Battery Cable Lug, Failure
 VN, VHD

FSB 371-045, Battery Cable Lug, Failure

(May 2013)

W2080360

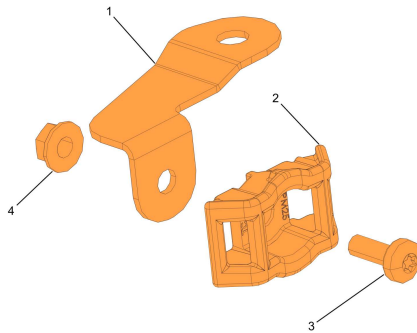
- 1 Secure the vehicle for service by parking it on a flat level surface, applying the parking brake, chocking the rear wheel, and placing the transmission in neutral.
- 2 Disconnect all cables from the negative (ground) battery terminals to prevent personal injury from electrical shock and prevent damage to electrical components.
- 3 Remove the fastener from the heat shield bracket.

W2080361

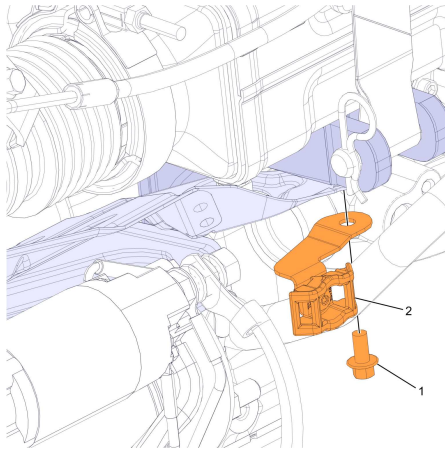
- 4 Preassemble the bracket and the saddle.

W2080362

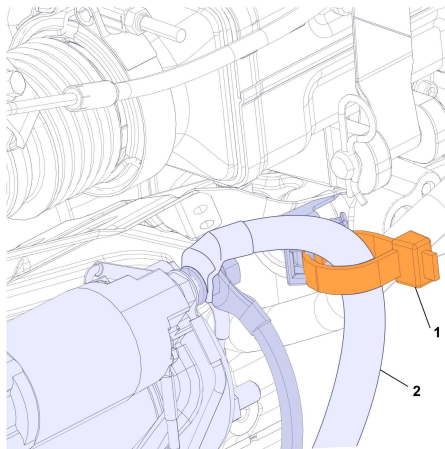
- 5 Install the bracket onto the vehicle and secure.
